February 4, 2020  
File No. 23212007.08

Subject: Village of St. Bernard Landfill  
Revised Explosive Gas Monitoring Plan/Request for Semiannual Monitoring

On behalf of the Village of St. Bernard, SCS is submitting the attached revised Explosive Gas Monitoring Plan (EGMP) for the closed St. Bernard Landfill. One clean electronic copy of the complete revised EGMP and red line addition and strike out copies of the revised pages are included with this submittal.

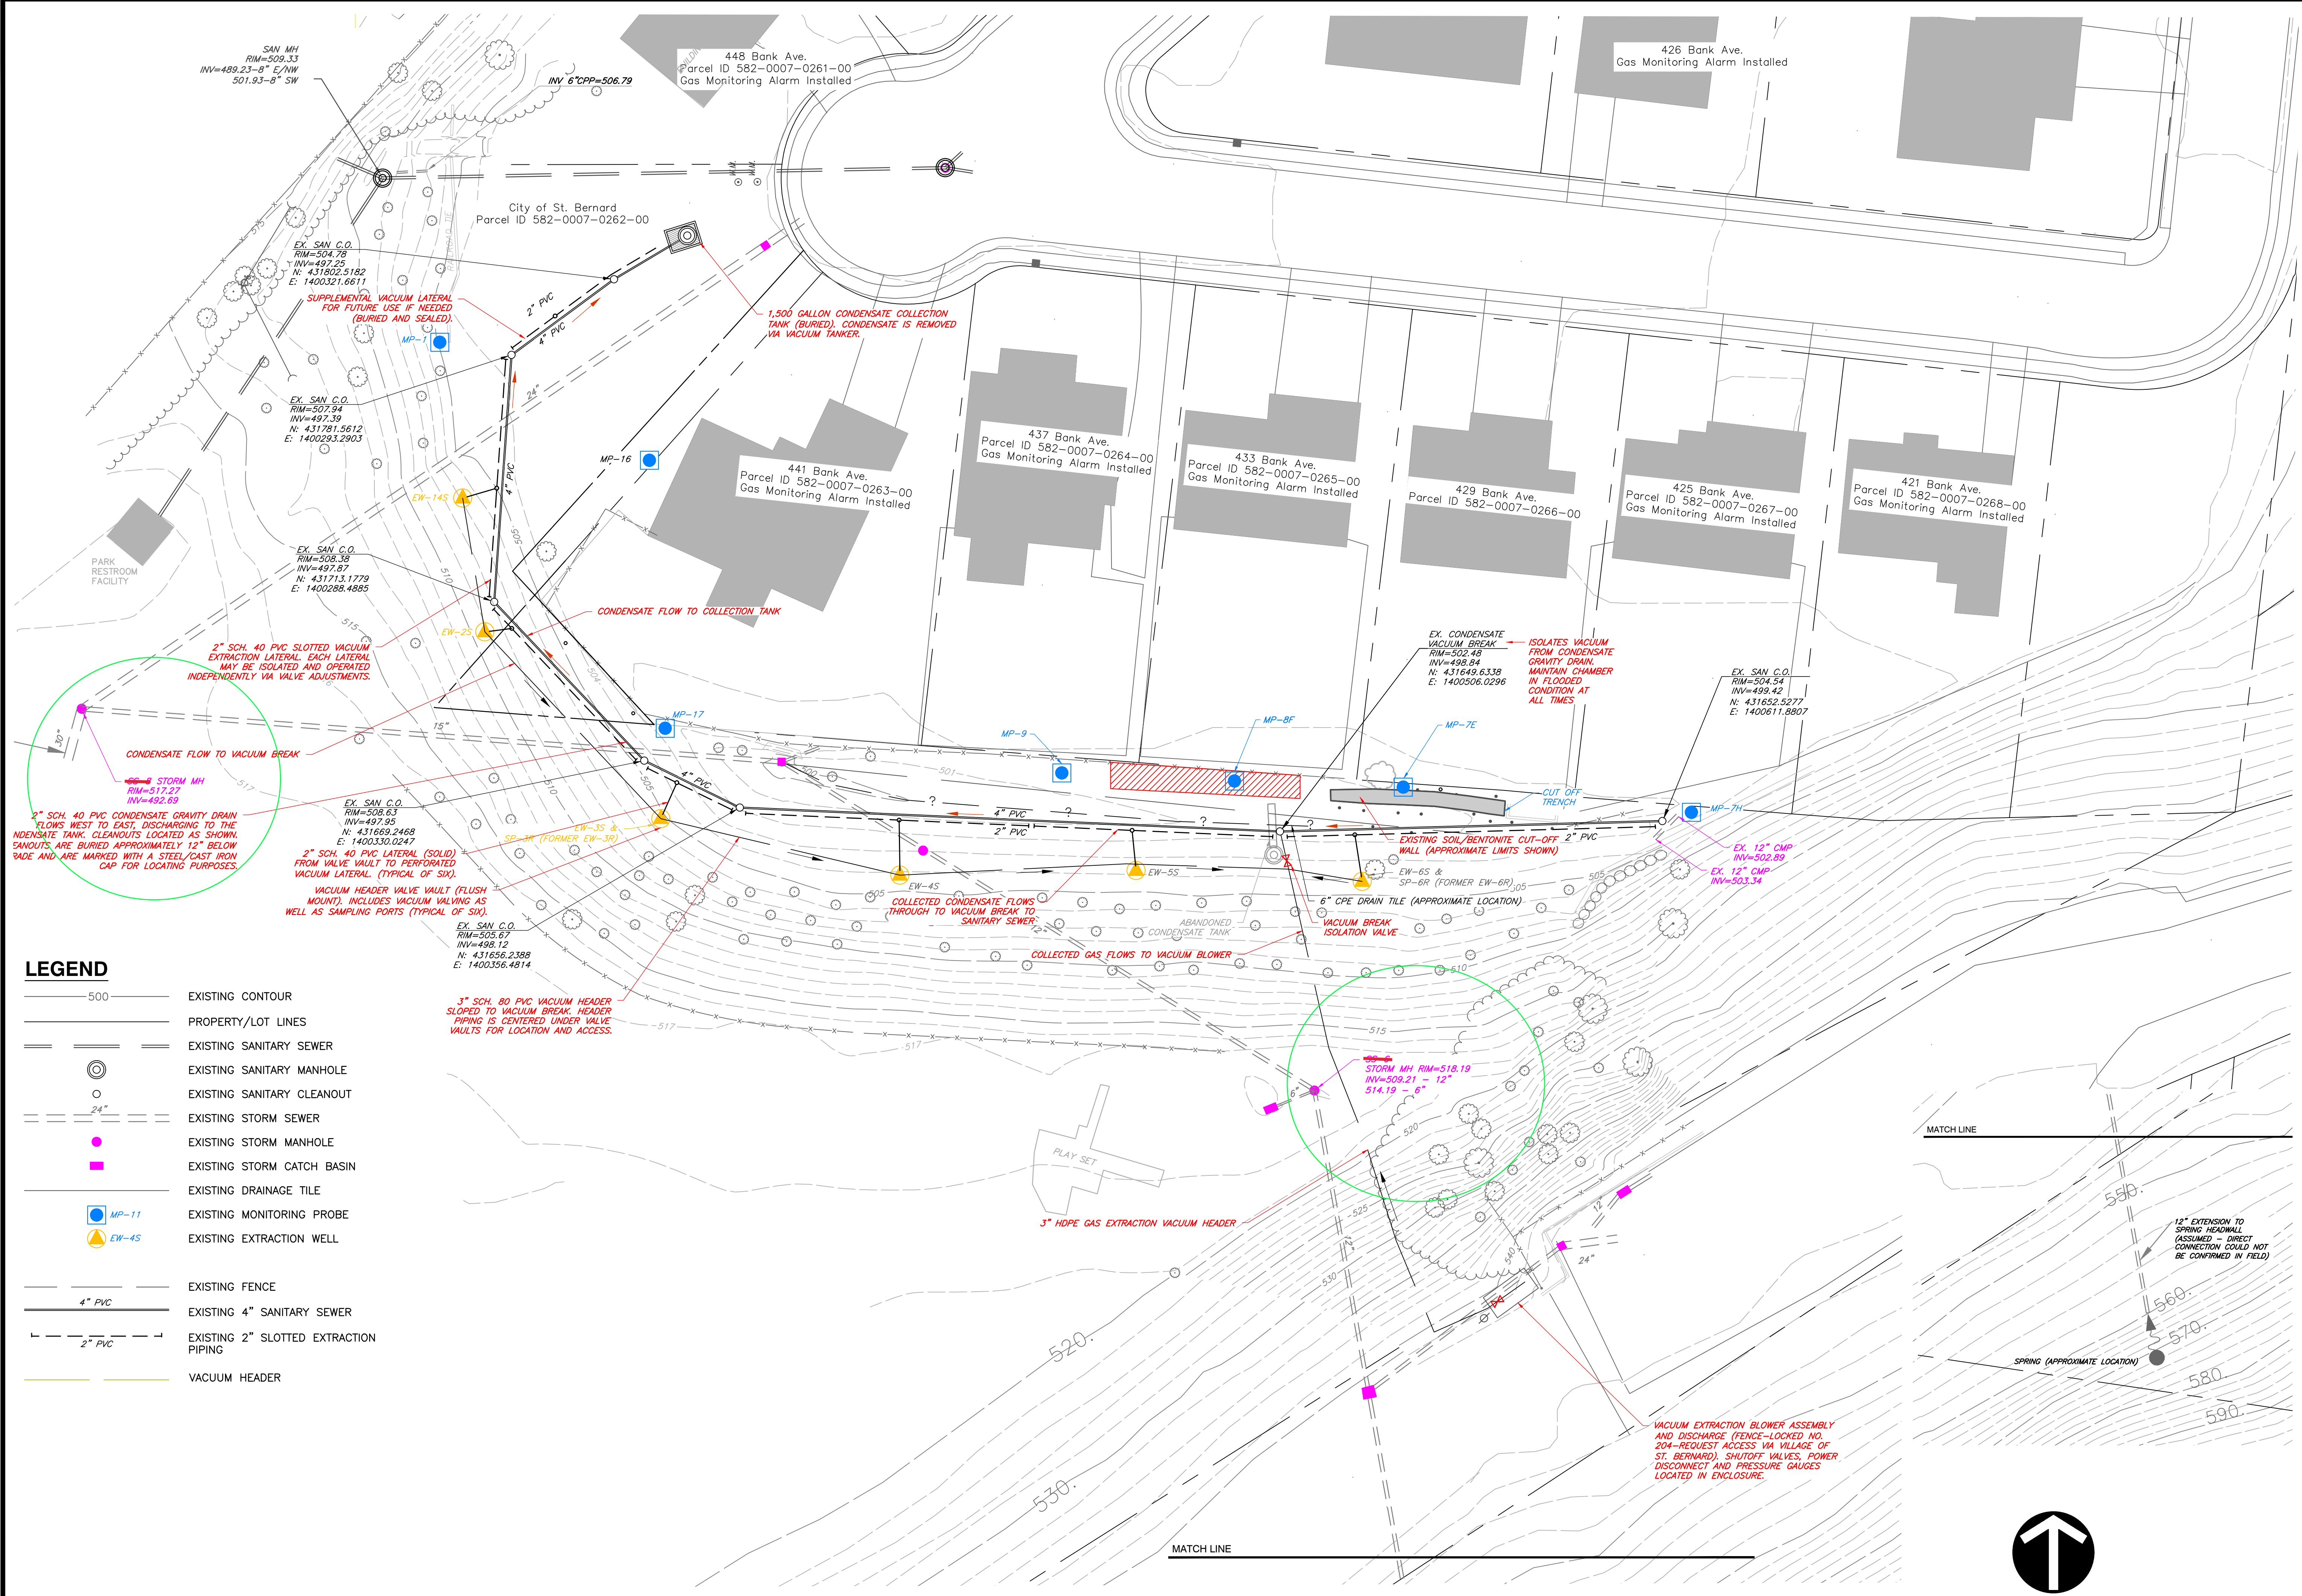
The minor changes include the elimination of the annual monitoring in the two storm sewer drop inlets located on the top of the landfill/soccer field and revising the description of the alarm set point concentration for the CGIs. Since SCS assumed the performance of the monitoring at the closed St. Bernard Landfill in 2012, no combustible gas has been detected in any of the storm sewers monitored in general and specifically at these storm sewer locations, previously designated SS-6 and SS-8 on the markup of Figure 4 of the EGMP.
